**RE: SSD System Determination Sampling Plan
Retail C, E1, E2 and F
Gateway Center at Bronx Terminal Market
Bronx, NY ("The Project")
BCP Site No. C203015
Langan Project No.: 5742506**

**RE: SSD System Determination Sampling Plan Addendum 1
Retail C, E1, E2, and F
Gateway Center at Bronx Terminal Market
Bronx, New York ("The Project")
BCP Site No. C203015
Langan Project 5742506**

Langan Engineering & Environmental Services, P.C. (Langan) is pleased to submit Addendum 1 to the SSD System Determination Sampling Plan, dated May 6, 2009 for Gateway Center at Bronx Terminal Market (the Site). This addendum provides our Sampling Plan modifications and responses to the NYSDEC comment letter dated June 11, 2009.

Project
PROPOSED INDOOR AIR/SUB-SLAB VAPOR SAMPLING LOCATIONS
 BRONX NEW YORK
 Project No. 170058501 Date 4/22/2009 Scale 1" = 125' Dwg. No. 1

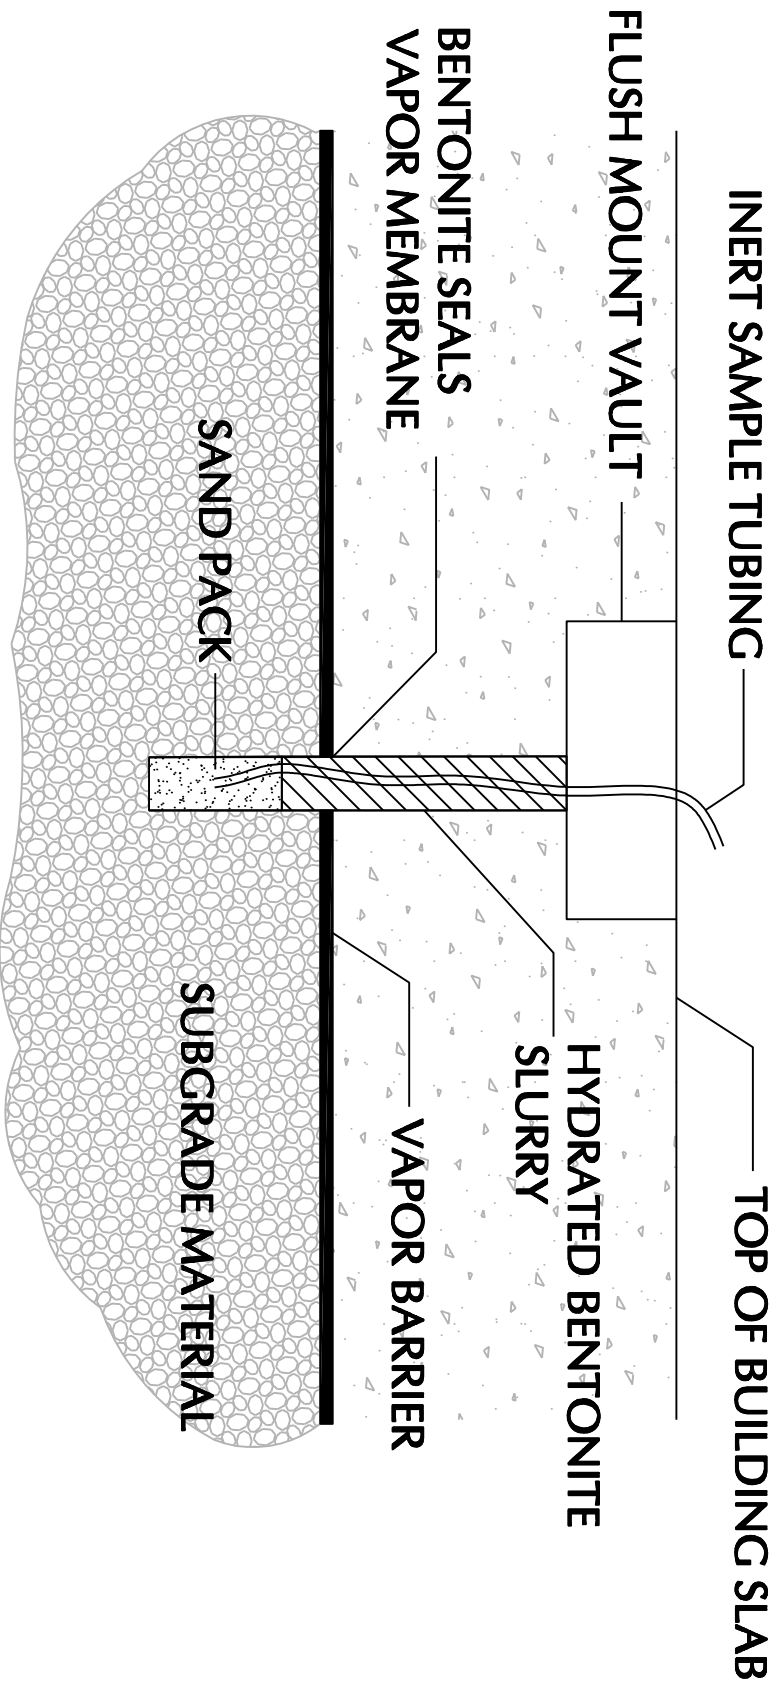
The post construction sampling locations should be representative, which may or may not include the extreme ends of the buildings. Please verify that these are considered representative.

The sampling locations are representative for conditions associated with commercial structures Retail E1, E2 and F. These sample locations were selected as representative of these continuous (no obstructions) sub-slab spaces that are connected by a layer of pervious gravel and perforated piping, below a continuous vapor barrier membrane. Upon further consideration, for Retail C, we have added Sample Location C-3, considering that the sub-slab space under this building is divided into three areas by two grade beams running in an east-west orientation. With the addition of C-3, sampling will be undertaken within each of the three areas. At all sampling locations both indoor air and sub slab soil vapor samples will be collected simultaneously for an approximate period of 8 hours. The revised sample location map is provided as Attachment B.

GATEWAY CENTER AT BRONX TERMINAL MARKET
**SOIL VAPOR VOC AND METHANE
DETECTION MAP**
BRONX NEW YORK

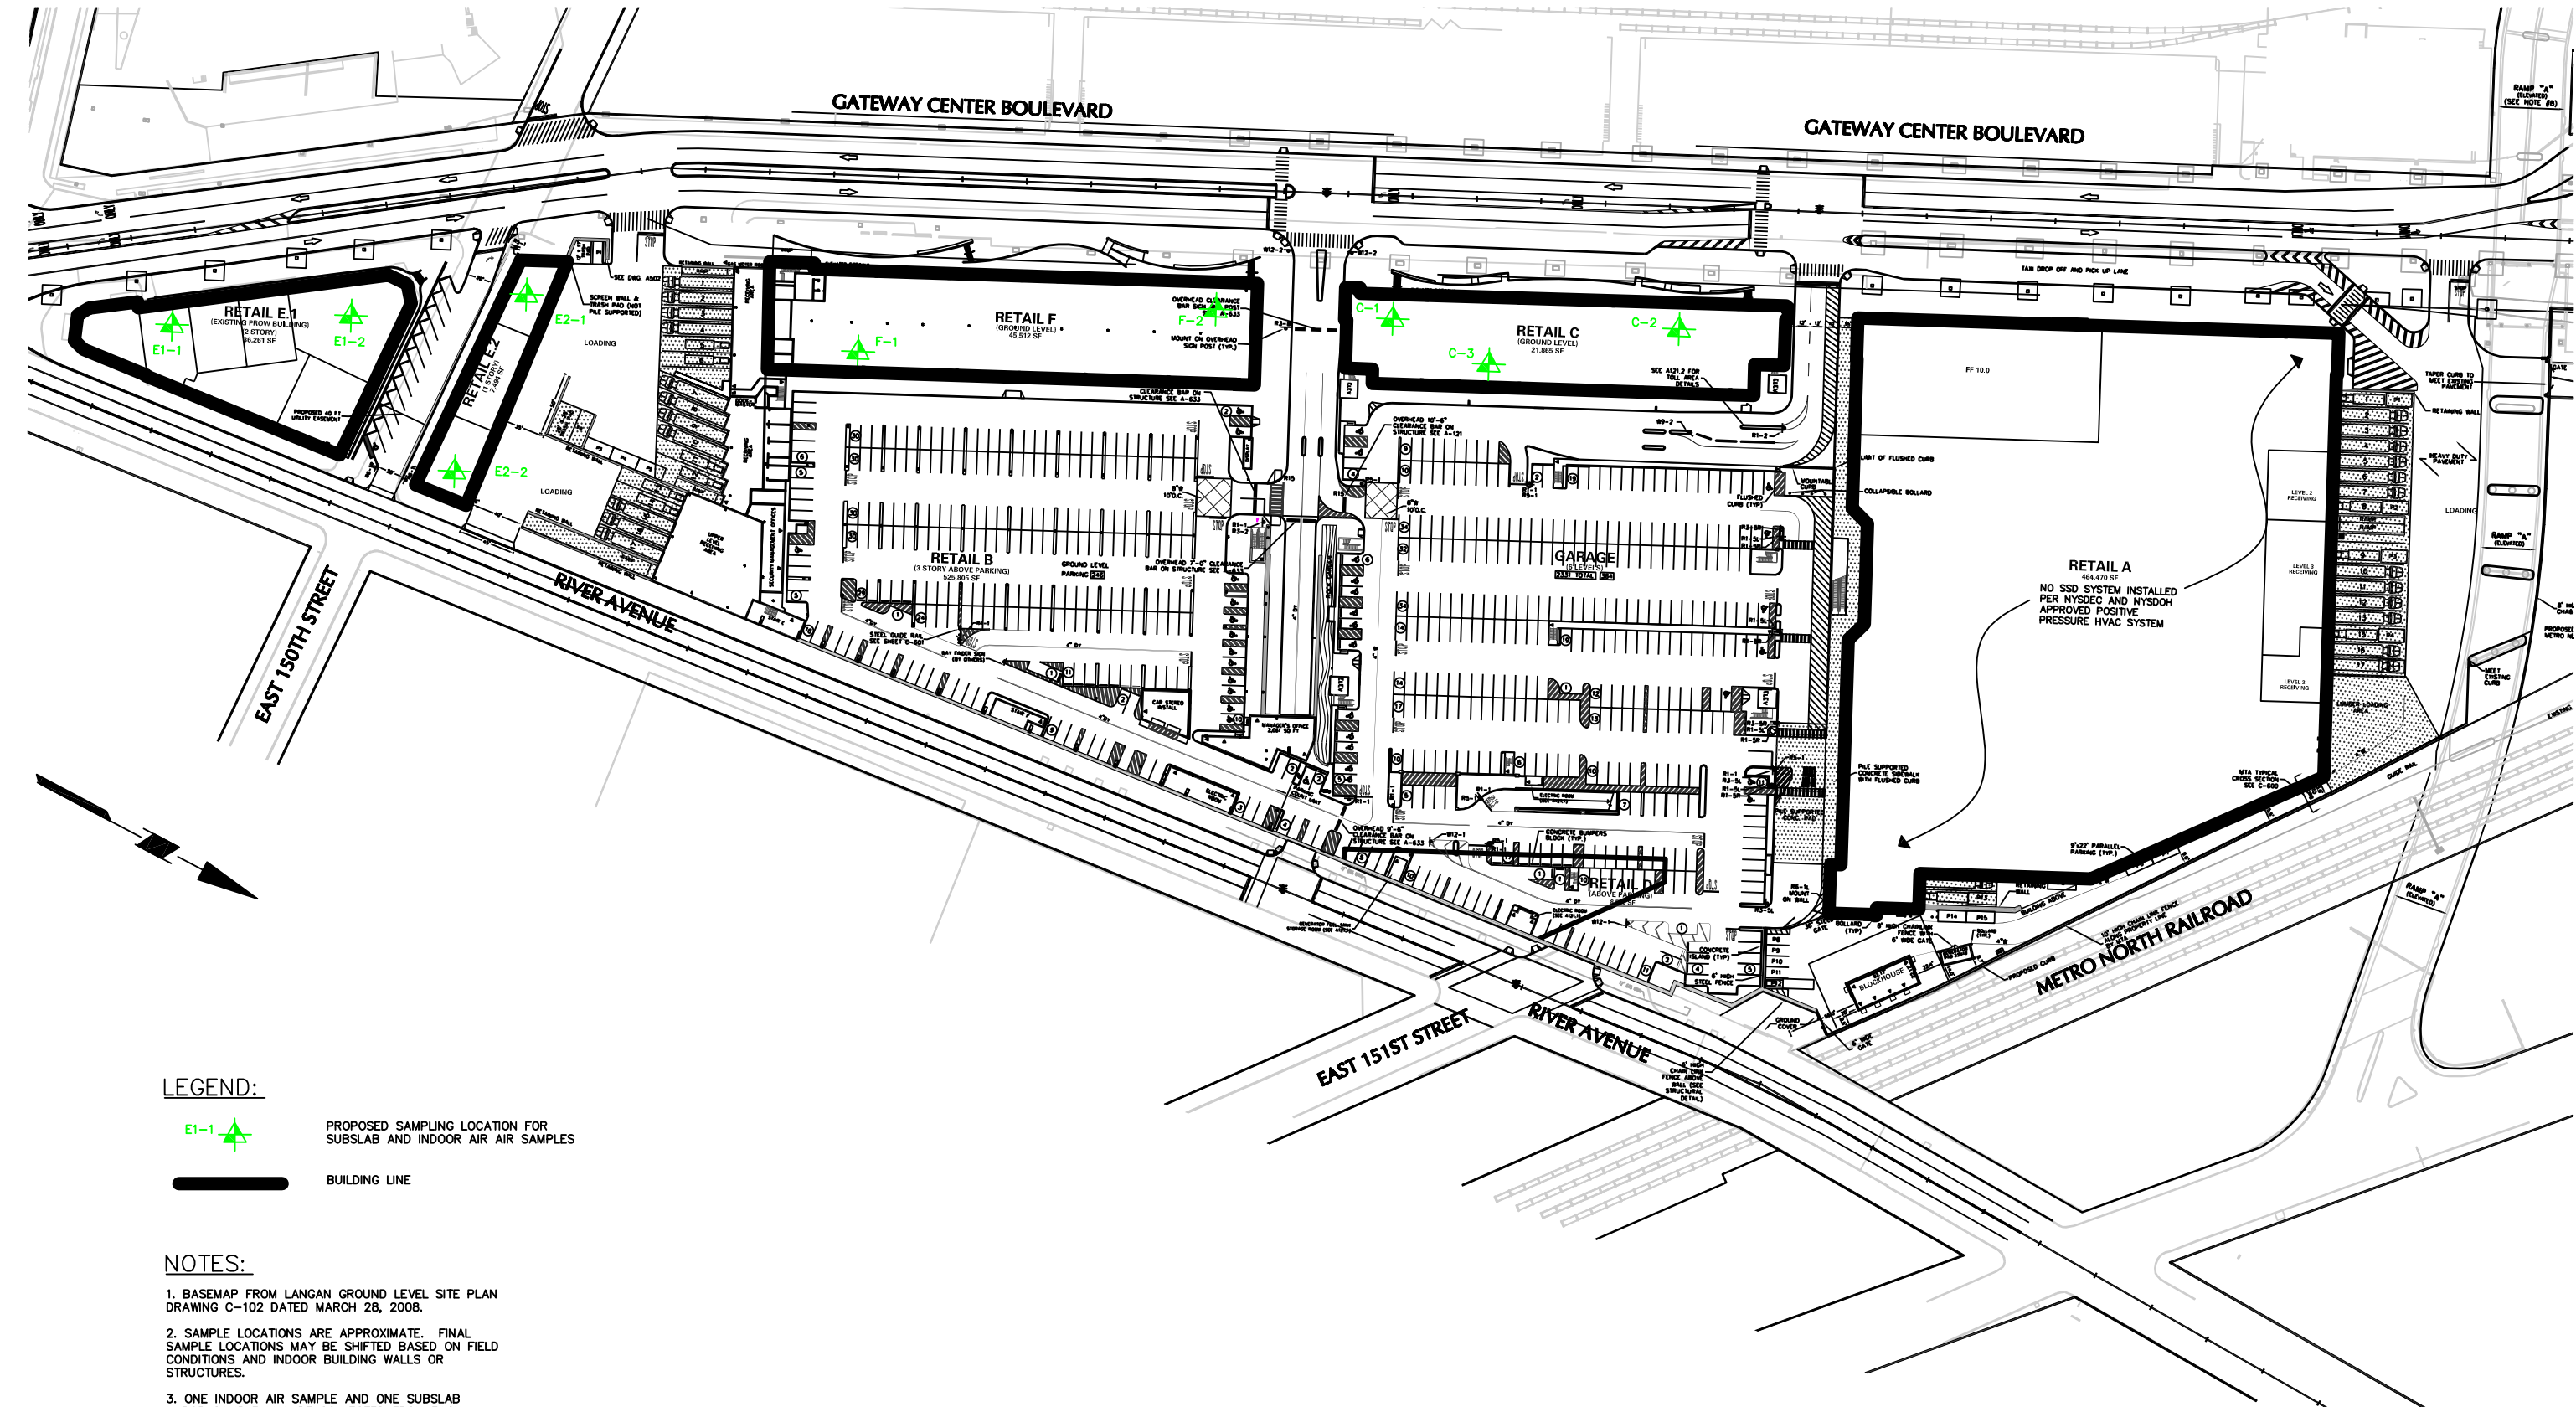
Attachment 1 was not included with the sampling plan.

The referenced attachment is a soil vapor volatile organic compound (VOC) and methane detection map and shows sample locations and compound concentrations for the Site prior to the implementation of the Remedial Work Plan. The map is provided as Attachment A.
